RECREATIONAL
OFF-HIGHWAY
VEHICLE
ASSOCIATION

July 31, 2014

Re: ANSI / ROHVA 1-201X

On behalf of the Recreational Off-Highway Vehicle Association (ROHVA) Technical Advisory Panel, I write in response to your letter regarding the American National Standard for Recreational Off-Highway Vehicles, ANSI/ROHVA 1-201X.

Figure A¹

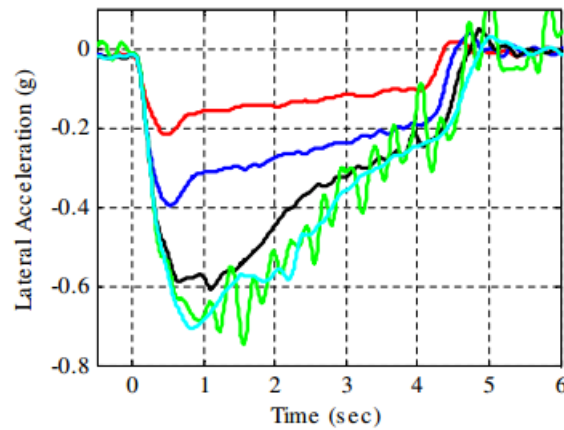
Moreover, even after filtering the data, the lateral acceleration curve, which is used to determine pass-fail in the Lateral Acceleration J-Turn, is a wavy line that varies between multiple tests. See, e.g., Figure A. This wavy line can change due to several factors such as tire tread, track temperature, equipment used, and where the equipment is mounted.

Figure B²

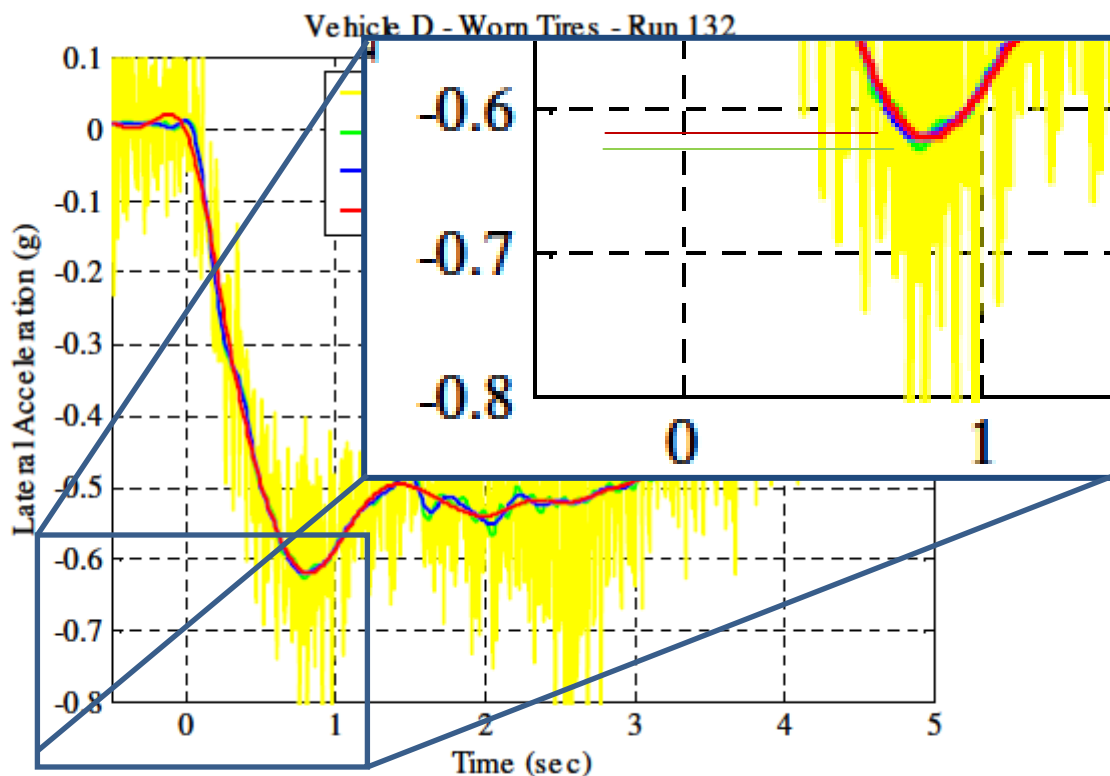
In addition, the filter and the subjective filtering technique utilized during the post-processing of the data has a material effect on the precision of the line and ultimately the value selected as the “peak lateral acceleration.” For example, in its original ROV testing for CPSC, SEA used a 5 HZ 8th Order Butterworth filter. See SEA (April 2011) at 24. In its lateral stability repeatability testing, in contrast, SEA used a 2 HZ Butterworth filter. See “Repeatability Testing of Four Recreational Off-Highway Vehicles,” CPSC Contract CPSC-D-11-0003, SEA, Ltd. Report to CPSC, September 2013 (“SEA (September 2013)”), at 2. The 2 HZ filter averages the actual measurements more significantly than the 5 HZ filter and eliminates the peaks and valleys of the trace. See, e.g., Figure B. This is problematic when “peak lateral acceleration” is the pass-fail metric.

Figure C

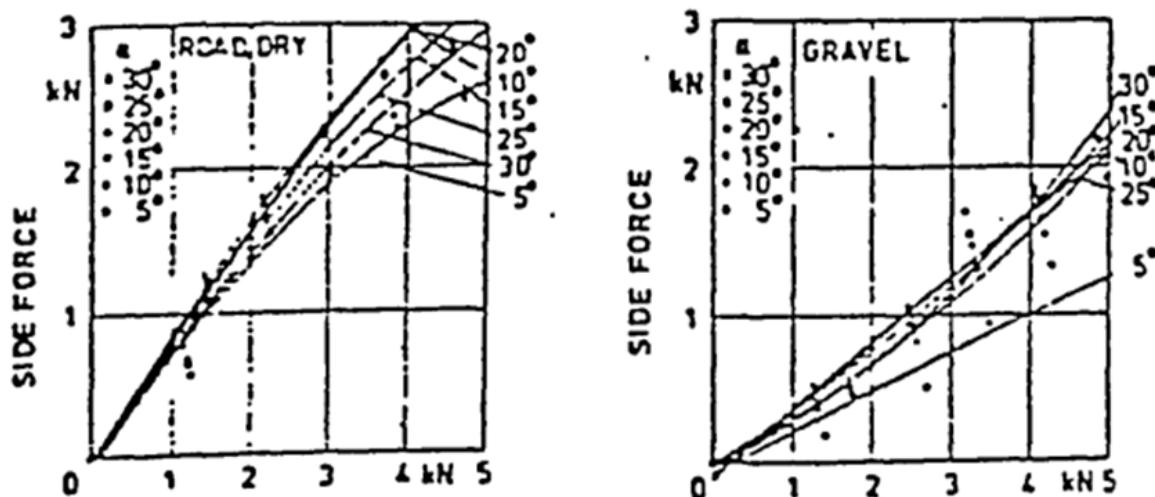
First, the understeer gradient measured on dry pavement is unlikely to represent the behavior achieved on off-highway surfaces. Force variation with load changes character dramatically with surface type – it is not simply a scaled version of the same character, as is the case with passenger car tires on an undeformable surface. See Figure D.

Figure C is taken from “Lateral Tyre Forces on Off-Road Surfaces”, El-Razaz, 1988 and shows on the left the typical convex characteristic for dry pavement with an entirely different concave characteristic on, for example, gravel. This complete reversal of the character of load sensitivity means that the handling character measured on dry pavement has at best a tenuous relationship to the handling character achieved off-highway in the intended operating environment.

Figure D⁵

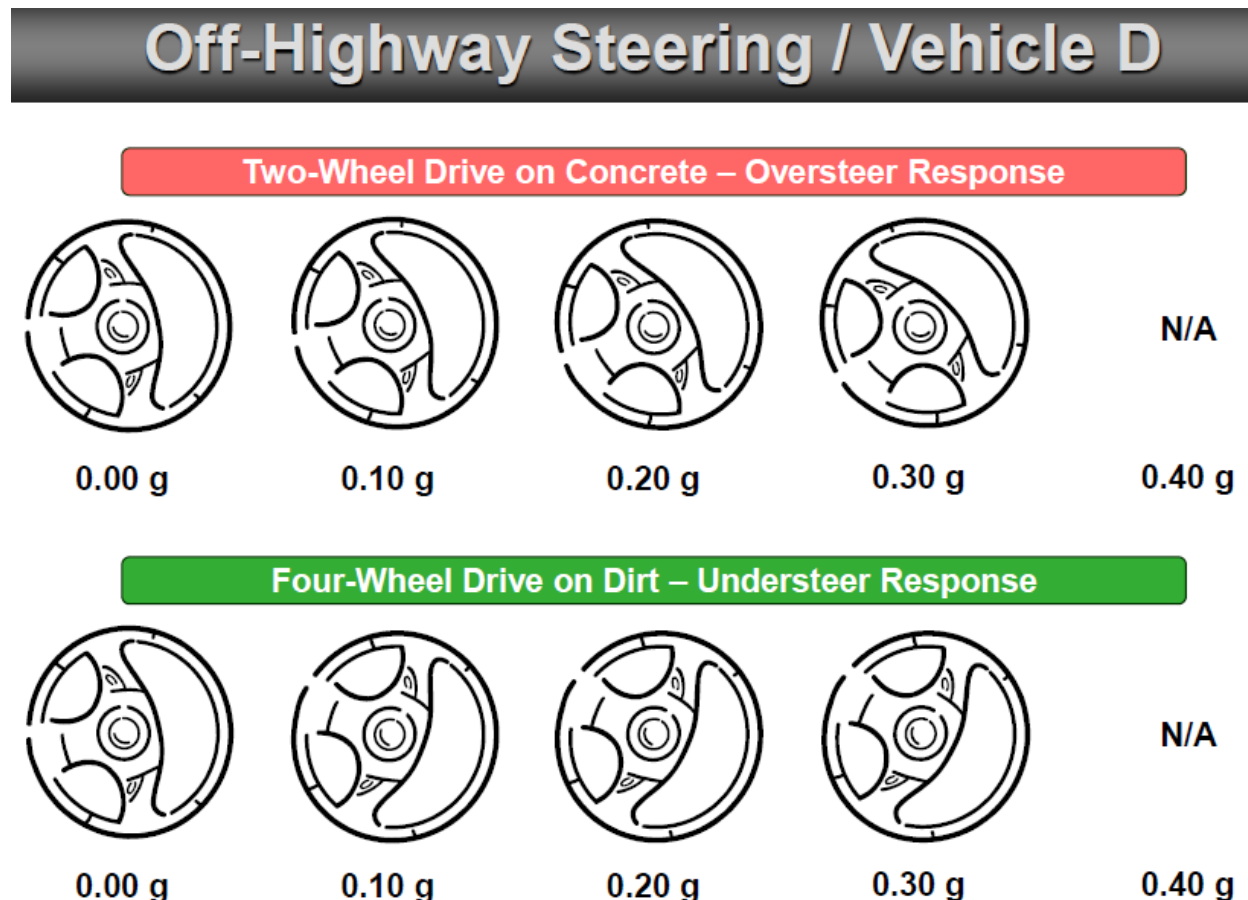
Second, the real world consequences of different understeer gradients, as measured by the required steering input to stay on path, are minor and, based on Brown (2012), equally appealing to the operator. Figure D, presented to CPSC staff by ROHVA on November 10, 2011, illustrates both the differences in performance by surface and the minor change in required input.

Figure E

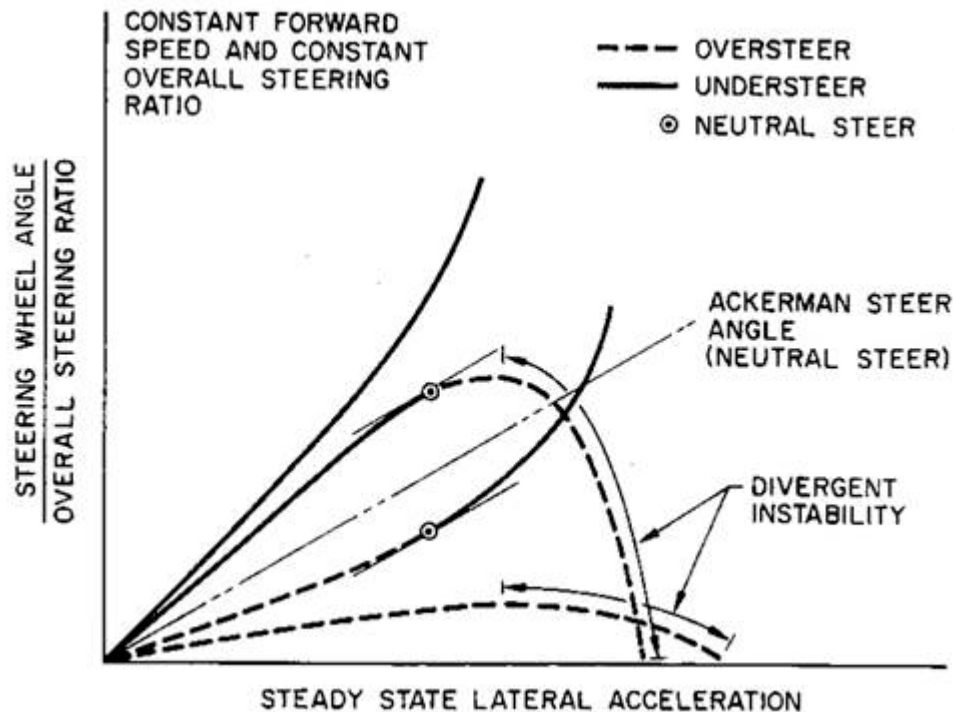
For these reasons, ROHVA continues to oppose a pass-fail standard associated with understeer gradient. Compare Figure F (below) with Figure E (above) taken from Gillespie's "Fundamentals of Vehicle Dynamics". This figure is associated with a constant speed test (rather than a constant radius test) and demonstrates that:

- i. oversteer vehicles can be stable; and
- ii. the transition from understeer to oversteer in any case does not mark the onset of divergent instability, which instead comes at a higher lateral acceleration (this transition being more readily visualized with the constant speed test).

If the objective is to ensure safe handling of vehicles, ROHVA believes that the proposed pass-fail criterion ("always understeer to 0.5g") is inappropriate. The premise for such a pass-fail standard – that oversteer is implicitly connected with divergent instability – is false, as explained by Gillespie.

Figure F

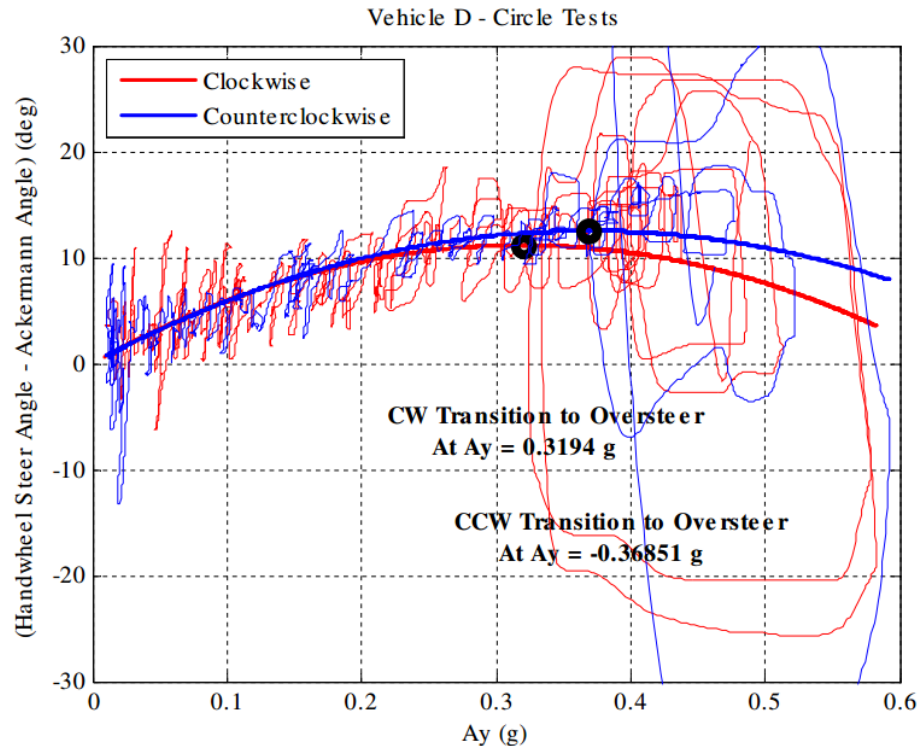
Moreover, measuring and plotting the understeer gradient for an ROV is not precise and generally not repeatable, and thus is not an appropriate metric for a standard. To demonstrate this situation, see Figure F from the report prepared by CPSC's contractor, SEA Ltd. Specifically, the raw data create an erratic trace line. The regression line that subsequently is fitted is the result of the post-processing interpretation of the data, which can vary widely depending on the analysis employed.

As such, understeer gradient is not appropriate for a pass-fail standard. The use of a polynomial function as shown in Figure F is entirely arbitrary and has no known relationship to the behavior of pneumatic tires, see for example "Tire and Vehicle Dynamics", 3rd Edition 2012 by Pacejka, in which complex functions are used to represent the non-linear behavior of vehicle tires on pavement, the vehicle behavior being the sum of the tire forces interacting with the mass and inertia of the vehicle in a readily understood manner, as described in, for example, Milliken & Milliken "Race Car Vehicle Dynamics", 1995. The extremely gentle curvature of the dataset along with the high degree of unavoidable noise in the data (due to tire tread lugs as described previously) mean that the accurate location of a turning point in the underlying data using such a method is susceptible to variations in noise and details of the curve fitting algorithm, as well as the actual function being fitted. These factors create an unsatisfactory level of uncertainty for a pass-fail standard.
